World Forum for Harmonization of Vehicle Regulations**Working Party on Pollution and Energy****Eightieth session**

**Light vehicles: UN Global Technical Regulations Nos. 15
(Worldwide harmonized Light vehicles Test Procedures (WLTP))
and 19 (Evaporative emission test procedure for the Worldwide
harmonized Light vehicle Test Procedure (WLTP EVAP))****Proposal for Amendment 3 to UN GTR No. 19 (Evaporative
emission test procedure for the Worldwide harmonized Light
vehicles Test Procedure (WLTP EVAP))****Submitted by the Informal Working Group on Worldwide harmonized
Light vehicles Test Procedure (WLTP)***

Amendment 2-3 to UN GTR No. 19 (Evaporative emission test procedure for the Worldwide harmonized Light vehicles Test Procedure (WLTP EVAP))

Figure A1/2

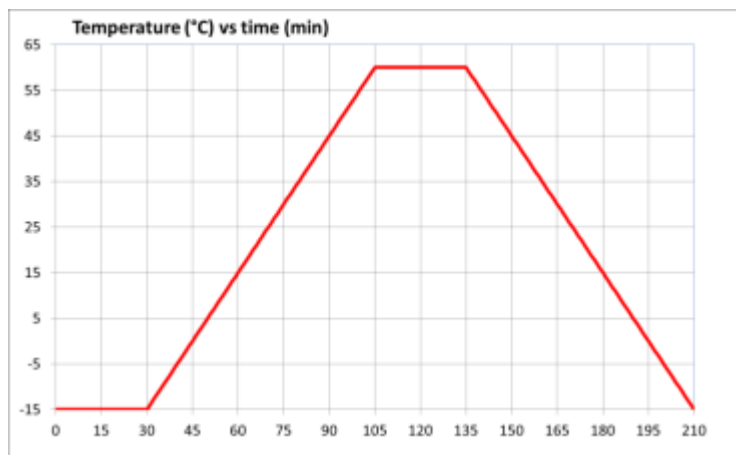
The carbon canister shall be cycled between temperatures from -15 °C to ~~60~~ 60 °C in a dedicated temperature enclosure with 30 minutes of stabilisation at -15 °C and 60 °C. Each cycle shall last 210 minutes (see Figure A1/2).
